ENGINEERING CHANGE ORDER			ECO No. <u>COS-074</u>	
Center for Astrophysics & Space Astronomy University of Colorado, Boulder			Date <u>5/20/02</u>	
			Sheet <u>1</u> of <u>9</u>	
Drawing/Document Title	Drwg/Doc No.	Revision Letter		Special Distribution
		Current	New	
COS Calibration	COS-01-0003	A	B	
Requirements & Procedures				Stop Production Now
				<input type="checkbox"/> Yes
				<input type="checkbox"/> No

Reason for Change: Update to reflect current information and include additional calibration procedures based on improved knowledge of the FUV detector performance.	Disposition/Effectivity				
	To Comply With ECO				
	Use As Is				
	Rework To ECO				
	Scrap And Rebuild				
	Record change Only				
	Other (See Above)				
Prepared By: <u>E. Wilkinson</u>	Date <u>5/20/02</u>	CCB Required		<input type="checkbox"/> Approved	
Approved By: _____	Date _____	<input type="checkbox"/> Yes <input type="checkbox"/> No		<input type="checkbox"/> NotApproved	
Approved By: _____	Date _____	<input type="checkbox"/> Class I <input type="checkbox"/> Class II		Immediate	
Approved By: _____	Date _____			Incorporation	
Approved By: _____	Date _____	<input type="checkbox"/> Yes <input type="checkbox

Figure 4.6-1: Flowchart representation of the counters in the FUV detector that are used to calculate the live time.

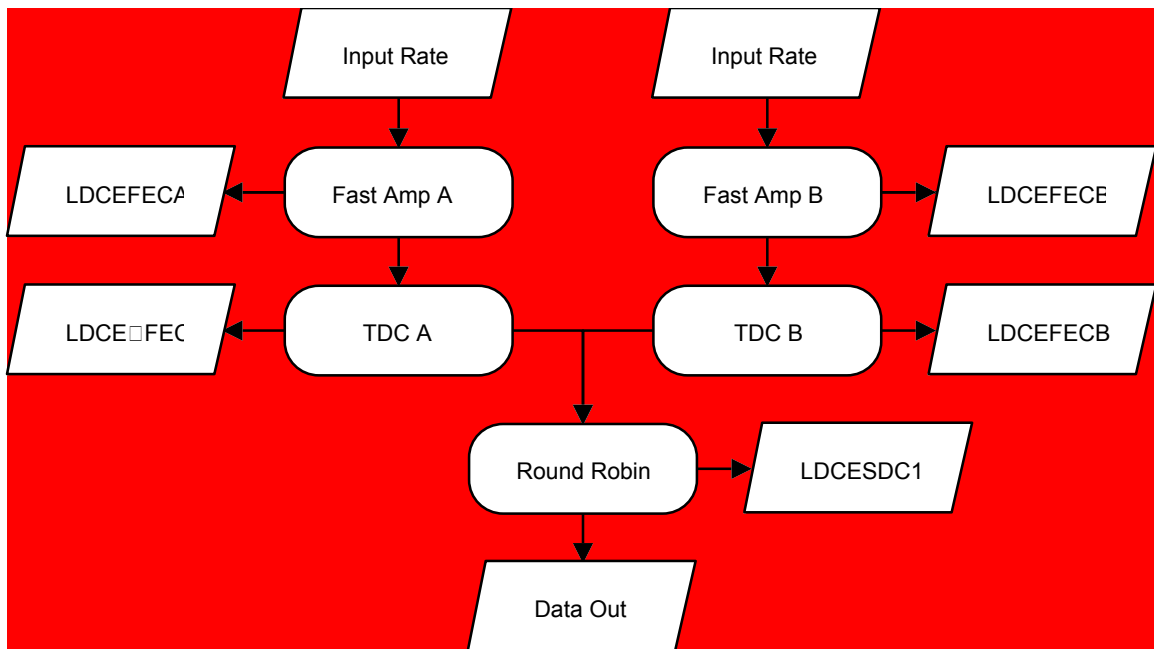
3. Page 23, section 4.2, 1st paragraph, 4th sentence: Change the last word from “data” to “positional data”.
4. Page 23, section 4.2, 2nd paragraph, 2nd sentence: Change the last clause from “where a uniformly distributed random value ranging from -0.5 to $+0.5$ pixels is added...” to “where a uniformly distributed value Δx , where $-0.5 < \Delta x \leq +0.5$ pixels, is added...”
5. Page 24, section 4.2, 1st paragraph, 4th sentence: Change “...distributed random number ranging from -0.5 to $+0.5$.” to “...distributed random numbers ranging from greater than -0.5 to less than or equal to $+0.5$.”
6. Page 33, section 4.6.1; Insert the following new text in for section 4.6.1.

In the case of the FUV detector there are three places where live time is introduced into the system; the fast amplifiers, the time-to-digital converter, and finally the round robin, which is common to both detectors (See figure 4.6-1). This means that the live time between segments will likely be different based on the distribution of flux across the detector.

There are three counters that monitor the count rates throughout the processing and can be used to monitor and correct for the live time. The first are the fast event counters (**LDCEFECA & LDCEFECB**) that report output rate of the fast amplifiers. The digital event counters (**LDCEDECA & LDCEDECB**) report the output rate of the time-to-digital converters. Finally, the science data counters (**LDCESDC1 and LDCESDC2**) report the output rate of the round robin.

COS FUV Spectrum of a Deuterium Lamp

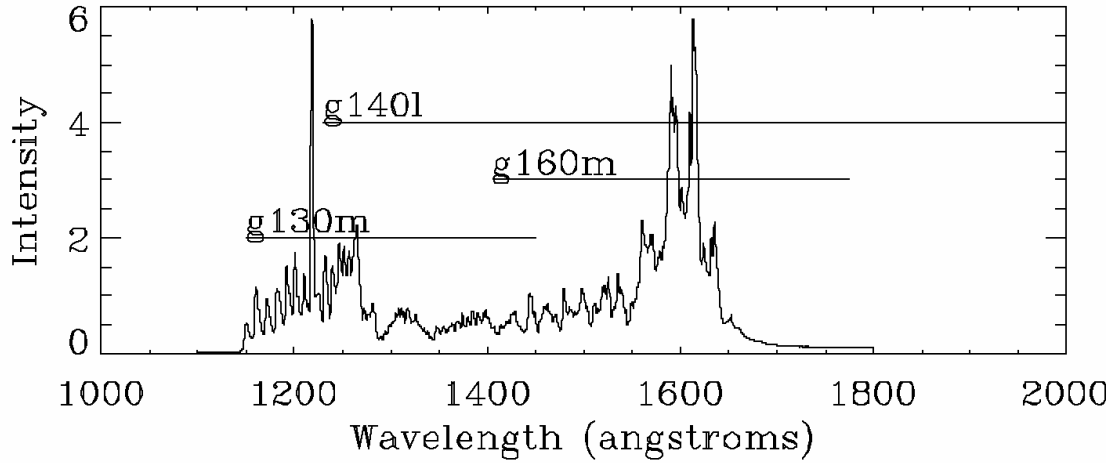
14. Page 65, figure 5.8-1, replace the figure with the one below

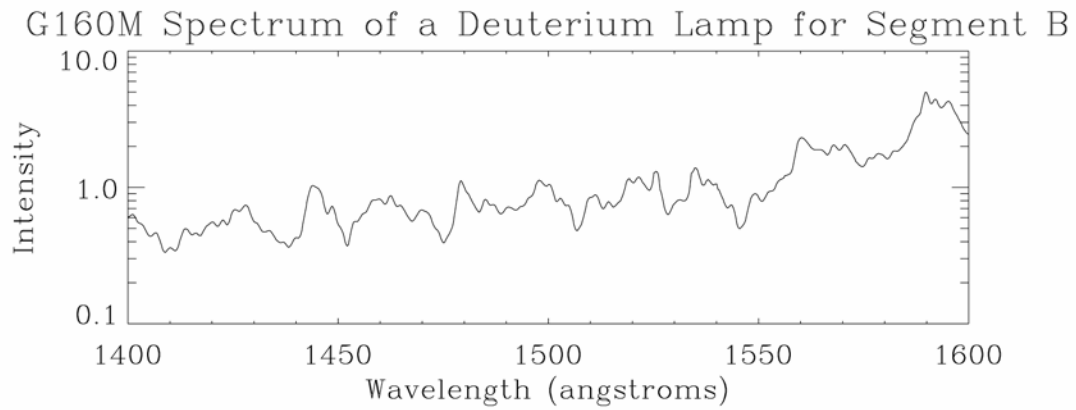
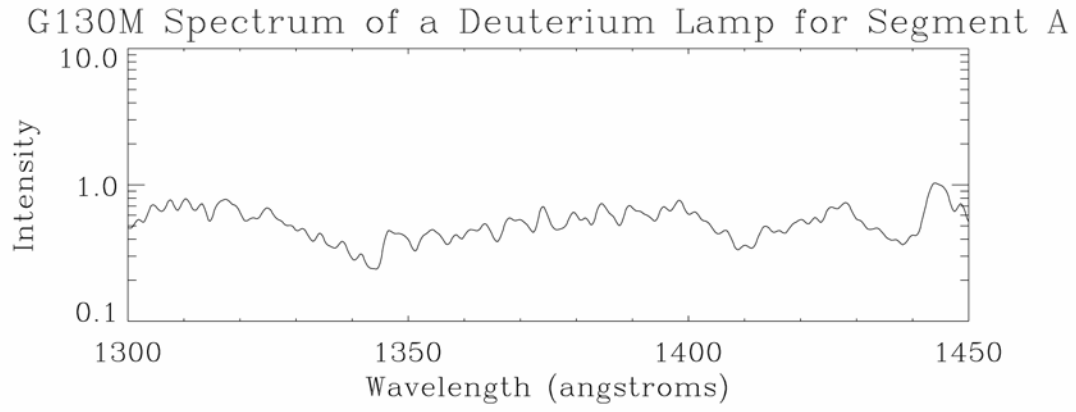
15. Page 65, figure 5.8-2, replace the figure with the one below. Also, in the figure caption replace "G140L" with "G130M"
